**BULLARD WASH CHANNEL IMPROVEMENTS PROJECT AND
ESTRELLA PARKWAY (BID CANAL TO YUMA ROAD)
IMPROVEMENTS PROJECT
PCN 4700731**

FLOOD CONTROL DISTRICT OF MARICOPA COUNTY

FLOOD CONTROL DISTRICT OF MARICOPA COUNTY**Bullard Wash Channel Improvements and
Estrella Parkway – BID Canal to Yuma Road Project****FCD 98-15****ADDENDUM NO. 2****November 9, 1998****Contract FCD 98-15****To Contract Documents****Title:** Bullard Wash Channel Improvements and
Estrella Parkway – BID Canal to Yuma Road Project**Owner:** Flood Control District of Maricopa County

This Addendum No. 1 modifies or clarifies Contract FCD 98-15. All other provisions of the contract remain unchanged unless specifically modified herein. The Addendum No. 1 forms a part of the Contract Documents and modifies them as follows:

TRAPEZOIDAL CHANNEL SECTION
 CONCRETE CHANNEL LINING
 East Tributary Channel
 Sta 0+43 ± to 21+90.22
SECTION B3
 N. T. S.

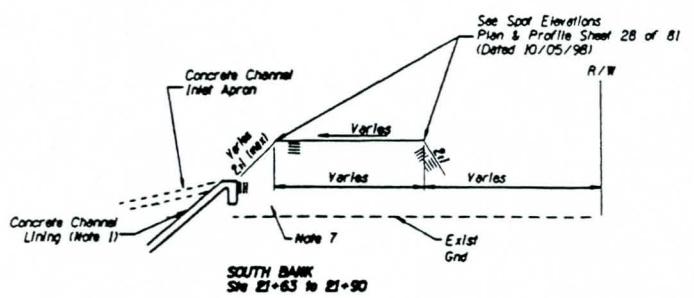
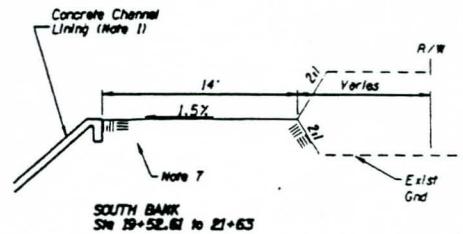
In Section B3; The south bank channel lining height will vary as follows – “Station 0+49[±] to 0+55 - the south bank height varies 7.3’ to 7.0’, Station 0+55 to 21+62.73 – the south bank height is 7.0’, Station 21+62.73 to 21+90.22 – the south bank height varies 7.0’ to 0.9’.” Refer to the revised Section B3 attached to and made a part of this Addendum No. 1.

In Section B3; The south bank fill condition section is modified with two sections to provide vehicle access along the top of the south bank between Stations 19+52.61 to 21+63 and 21+63 to 21+90. Refer to the revised south bank edge conditions shown with Section B3 that is attached to and made a part of this Addendum No. 1.

The south bank channel lining height will vary as follows – “Station 0+49[±] to 0+55 - the south bank height varies 7.3' to 7.0', Station 0+55 to 19+00 – the south bank height is 7.0'.” Refer to the revised Section B3 attached to and made a part of this Addendum No.1.

- Bank Height Varies (North Bank)
 9.0', Sta 0+50 ± to 10+00
 Varies, Sta 10+00 to 10+20
 7.0', Sta 10+20 to 21+62.73
 varies, Sta 21+63.73 to 21+90.22
 Bank Height varies (South Bank)
 Varies 7.3' to 7.0', Sta 0+49 ± to 0+55
 7.0', Sta 0+55 to 21+62.73
 Varies, Sta 21+62.73 to 21+90.22
- ** Distances Vary
 Sta 19+52.61 to 21+90.22
 See Plans
- *** Distances and
 Cross-Slope Varies
 Sta 21+62.73 to 21+90.22
 See Plans

PLAN AND PROFILE (EAST TRIBUTARY) STA 20+00.00 TO STA 23+00.00 SHEET OF

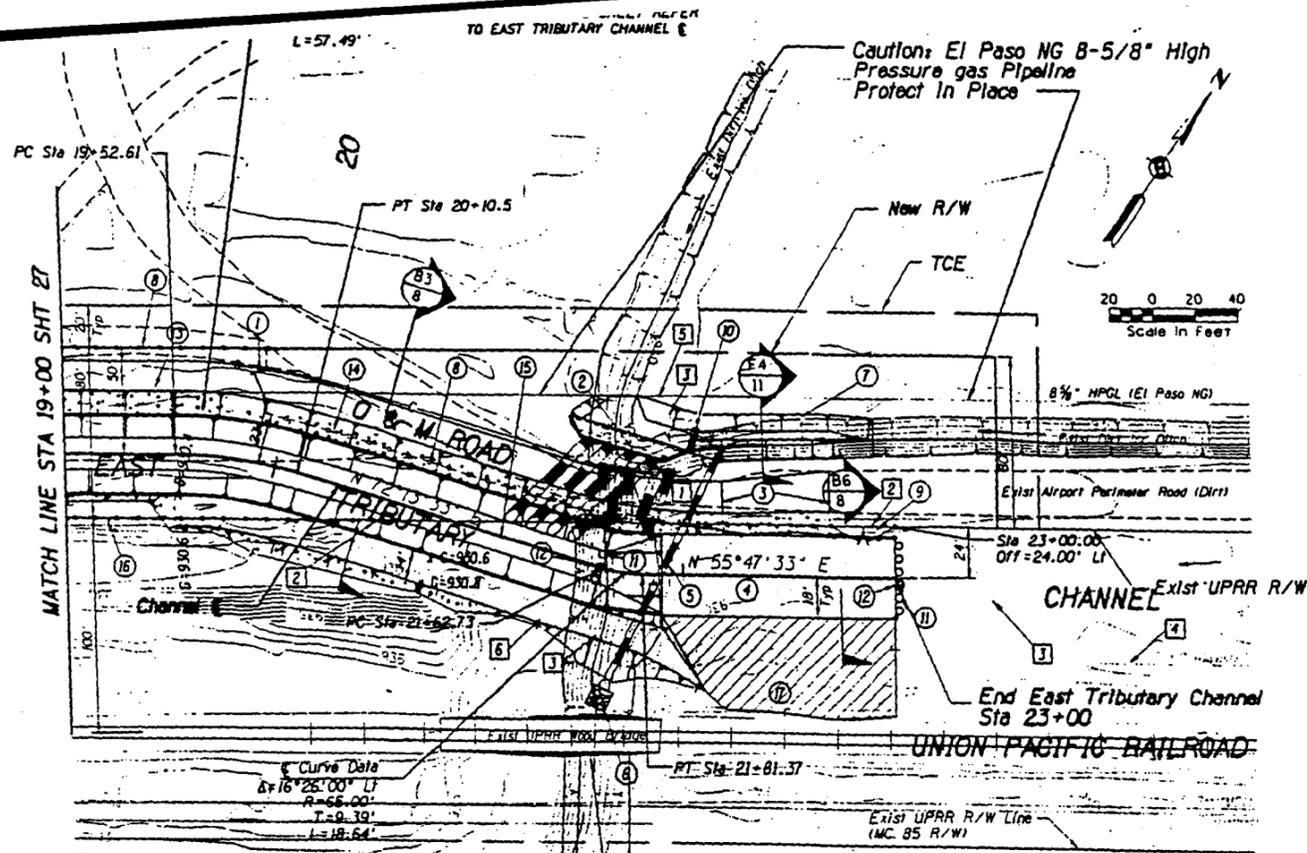
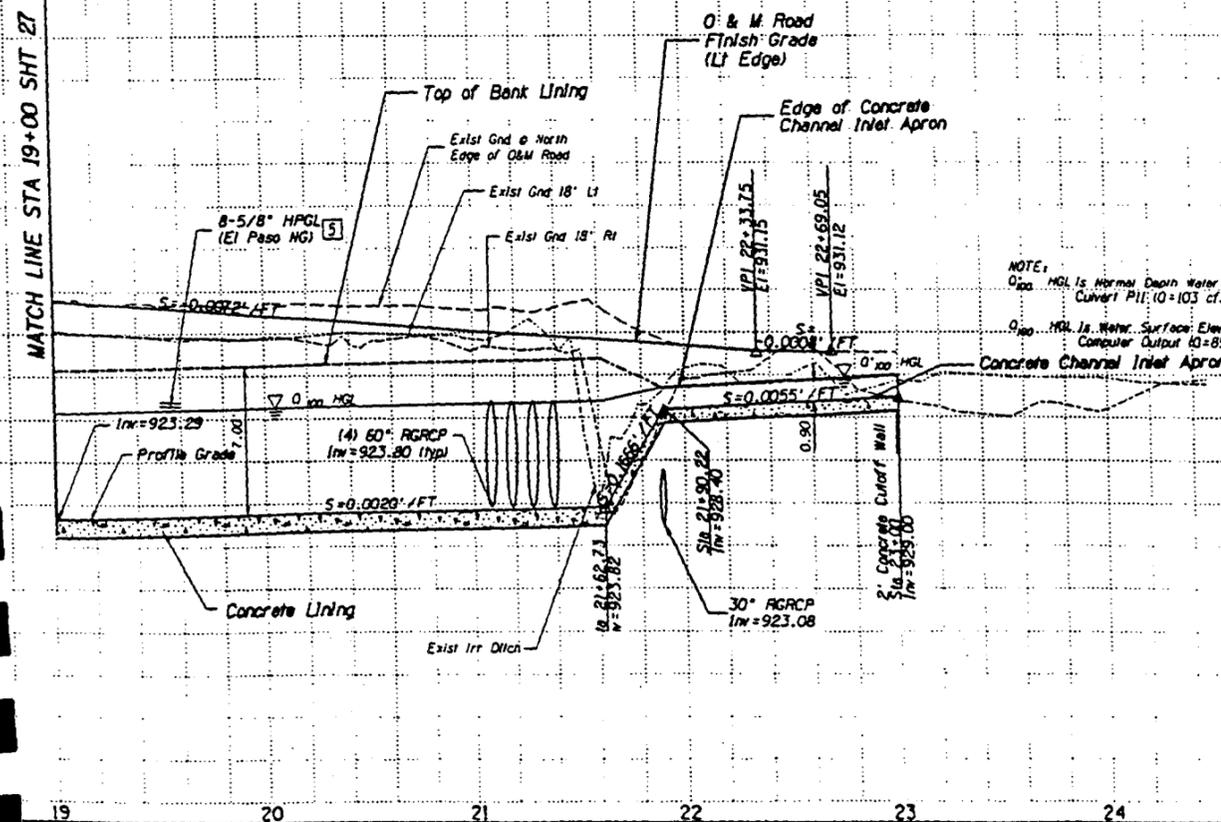
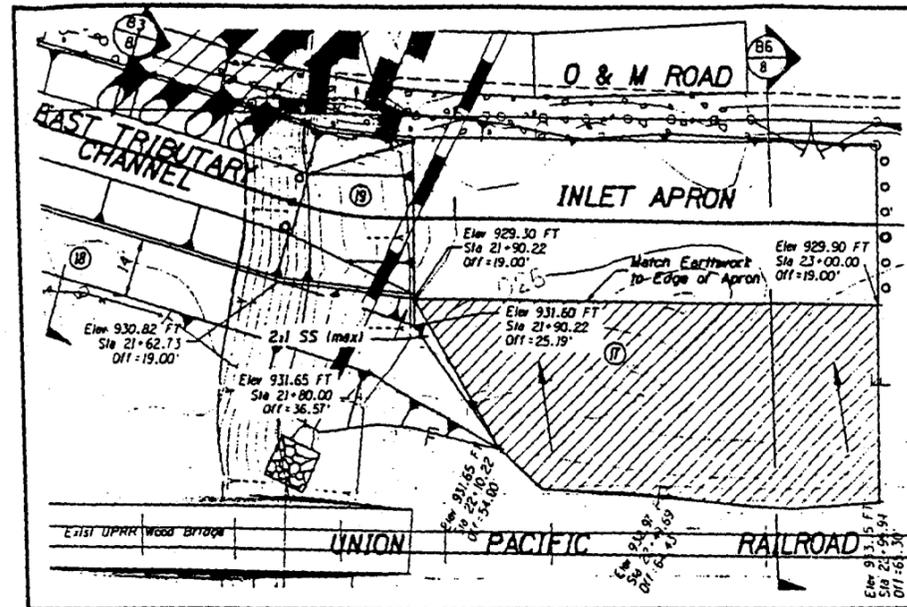
Clarification is provided regarding the placement of the fill area along the inlet end of the East Tributary Channel. The revised fill limits, elevations, compaction and grading requirements are shown on the revised sheet 28 of 81, attached to and made a part of this Addendum No. 1.

- 17 Fill In and Compact to 95% See Inset Detail For Spot Elevations
- 18 Compact Embankment to 95%. See (B3) (B8)
- 19 Channel Transition, Sec B3 to B6, Sta 21+62.73 to Sta 21+90.22

NO.	REVISION	BY	DATE
1	Added inset and notes 17-19
